ADDENDUM #1

**PROJECT: EMS STATION NO. 9
CITY PARISH PROJECT NO. 21-ASC-CP-1495**

**New EMS Station No. 9
8850 Connell's Village Lane
Baton Rouge, LA 70815**

CITY PARISH PROJECT NO: 21-ASC-CP-1495

MECHANICAL SCHEDULES

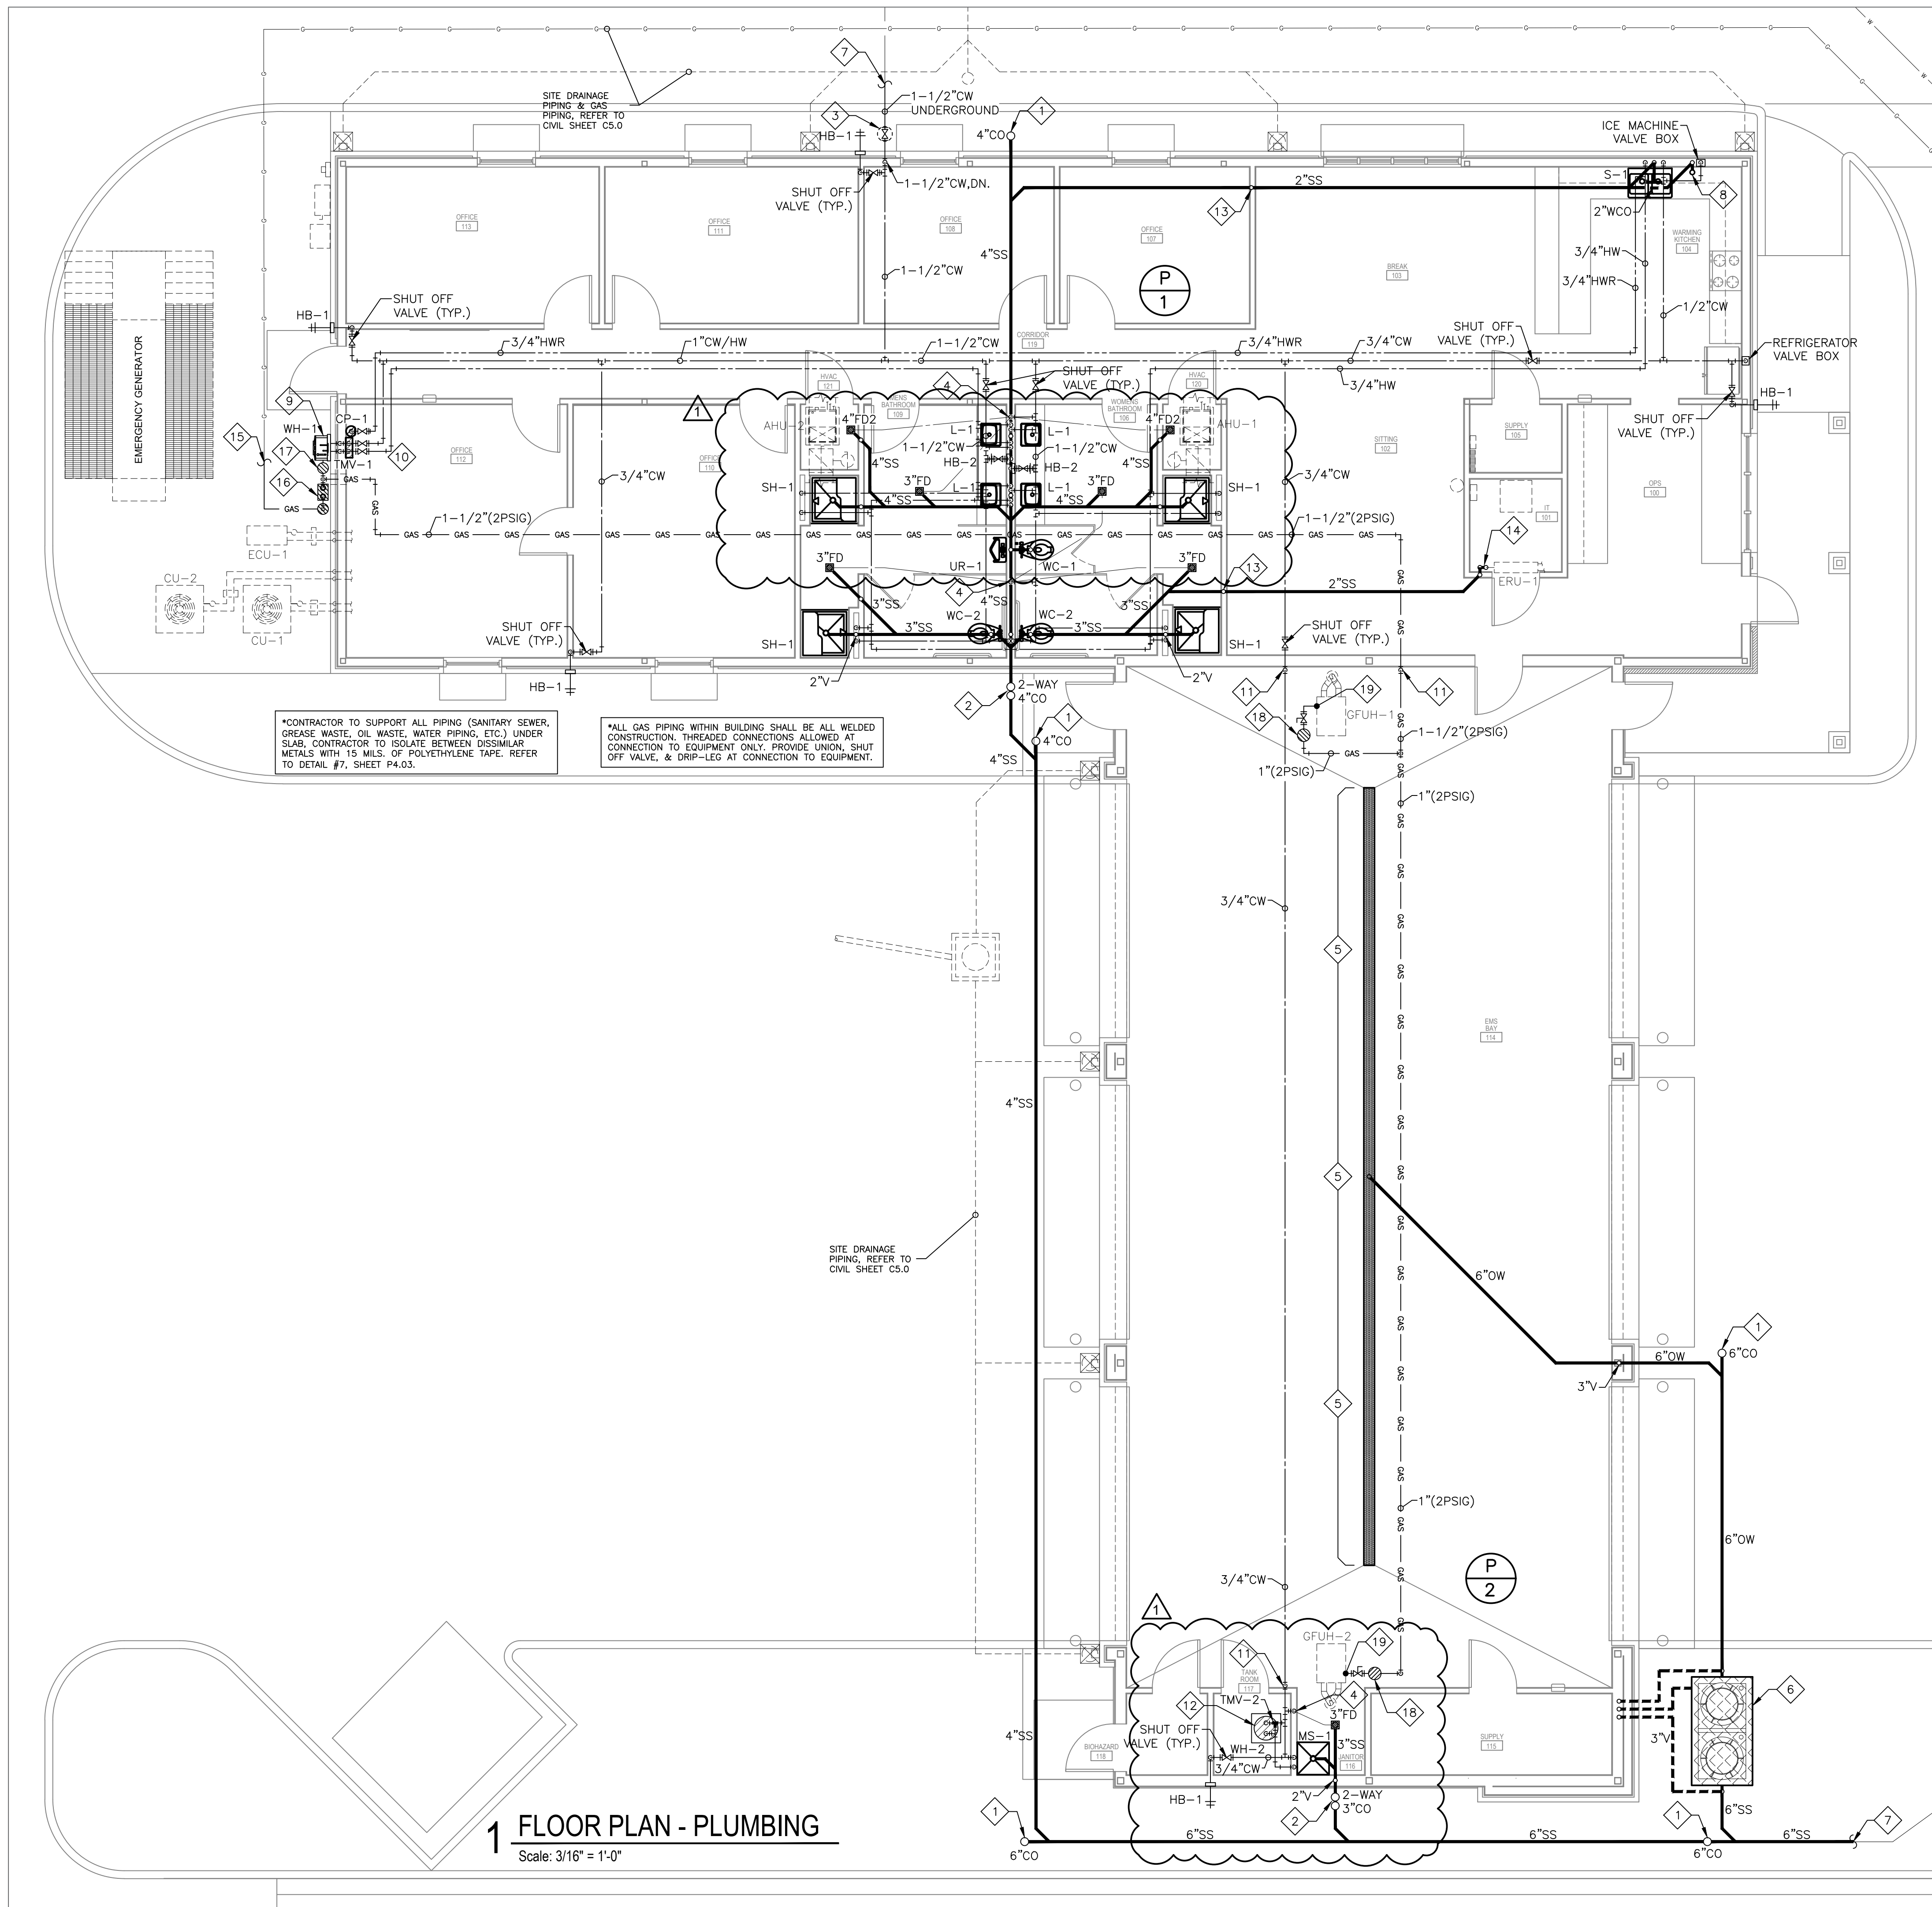
- Replace with attached Sheet A3.01, revisions include, but are not limited to, the following:
 - Revised EF-6 and respective ductwork routing
- Sheet M2.01 – Mechanical Schedules

- Remove Existing Sheet A2.01 from the bid documents
 - Replace with attached Sheet A2.01, revisions include, but are not limited to, the following:
 - Revised “Air Distribution Schedule”

- Sheet M2.02 – Mechanical Schedules
 - Remove Existing Sheet A2.02 from the bid documents
 - Replace with attached Sheet A2.02, revisions include, but are not limited to, the following:

- Revised “Exhaust Fan” (EF-6)
- Sheet P1.01 – Floor Plan - Plumbing
 - Remove Existing Sheet P1.01 from the bid documents
 - Replace with attached Sheet P1.01, revisions include, but are not limited to, the following:

PLUMBING DETAILS

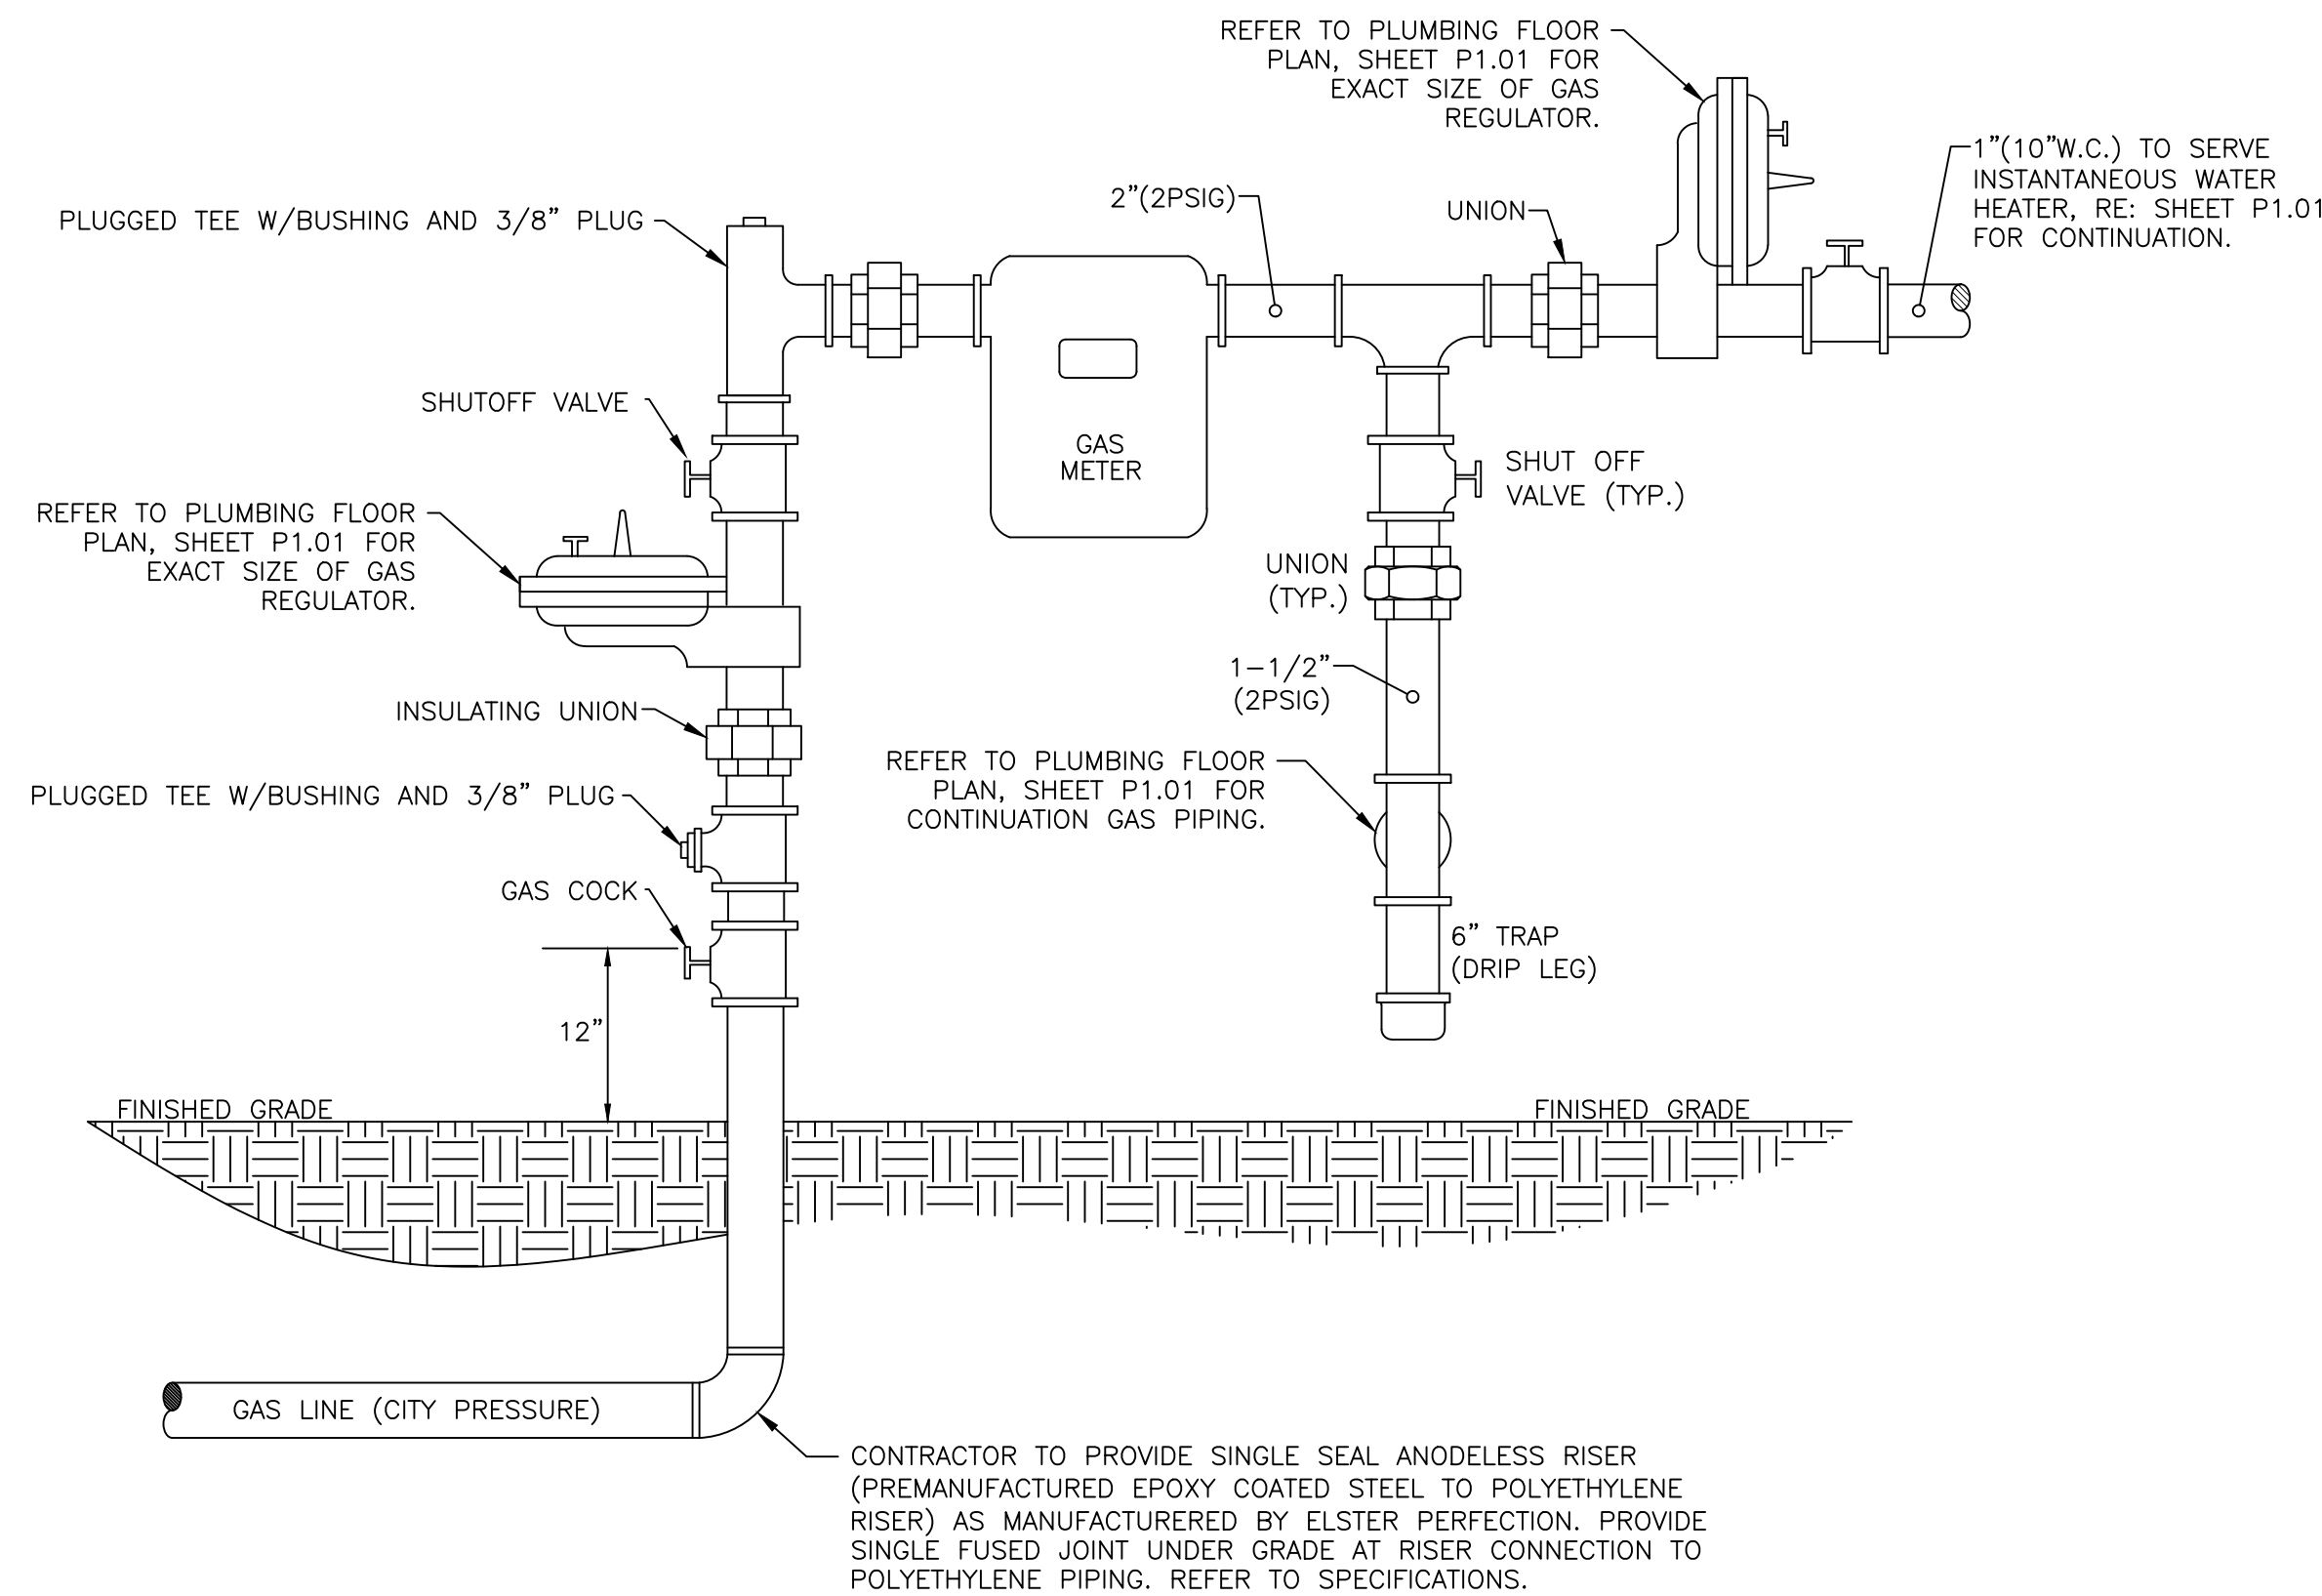
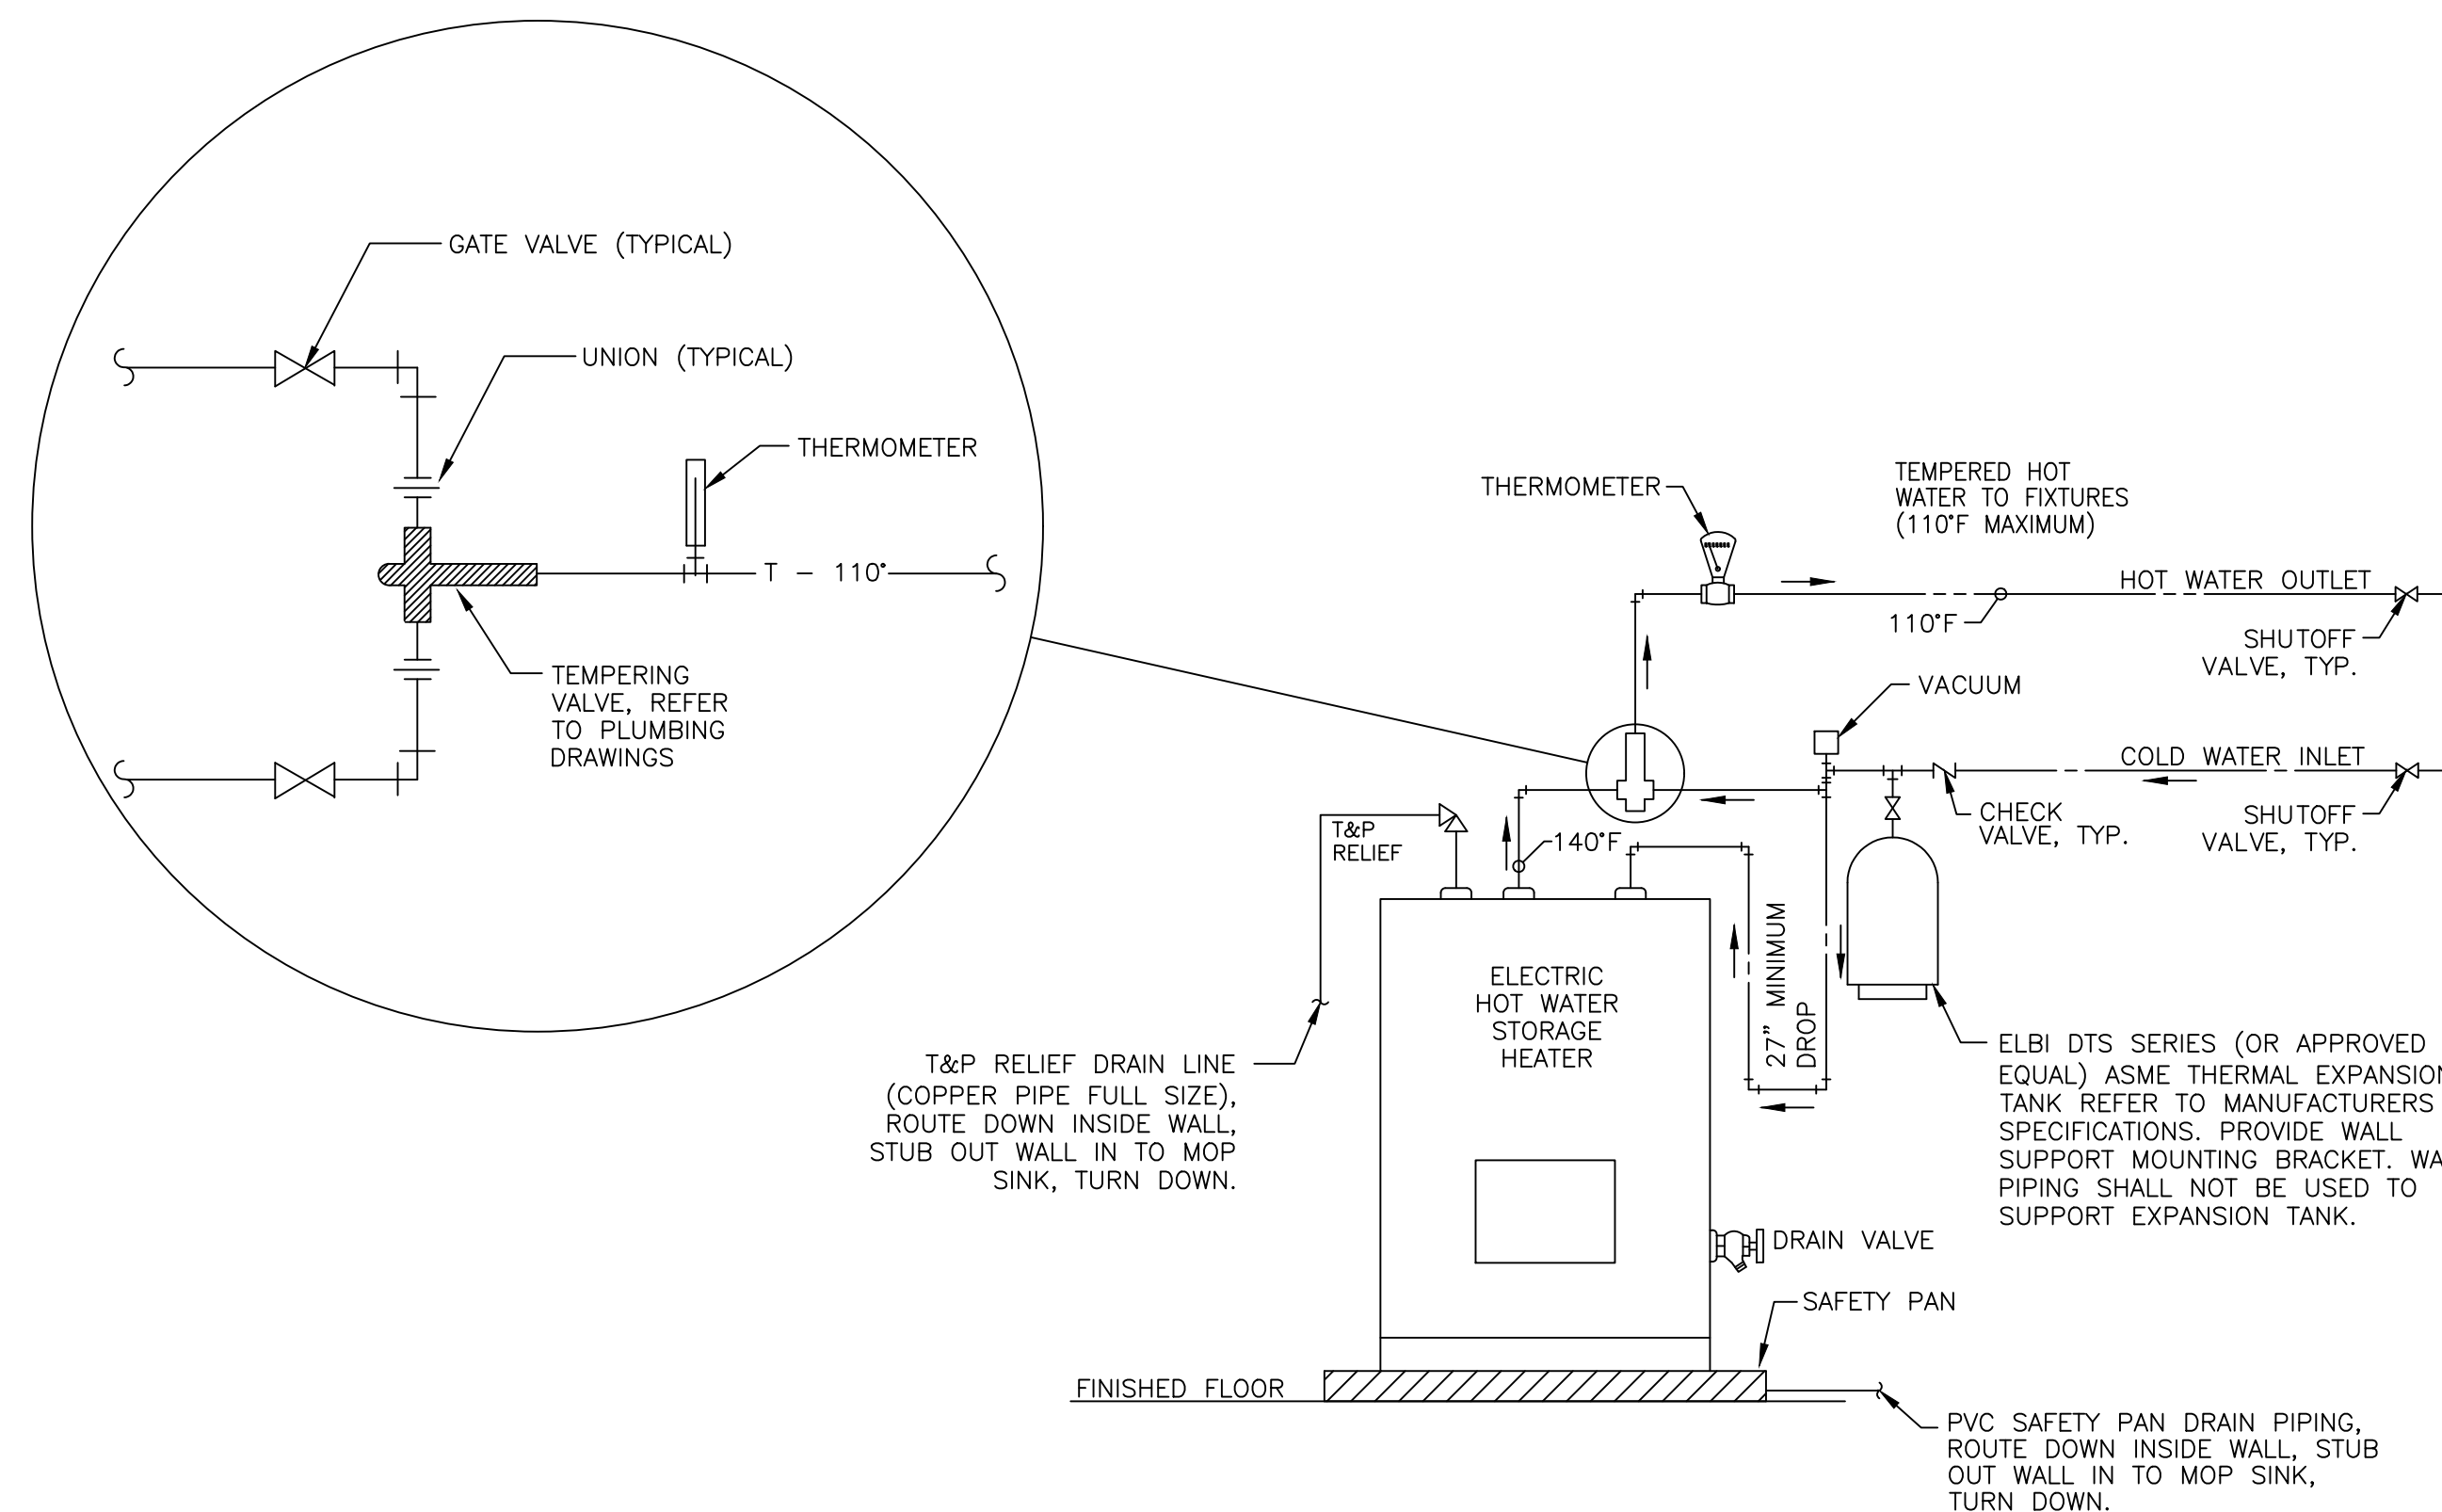
- Revised Plumbing Plan Keynotes
- Sheet P4.04 – Plumbing Details
 - Remove Existing Sheet P4.04 from the bid documents
 - Replace with attached Sheet P4.04, revisions include, but are not limited to, the following:

- Revised Detail #3, Electric Water Heater (WH-2)
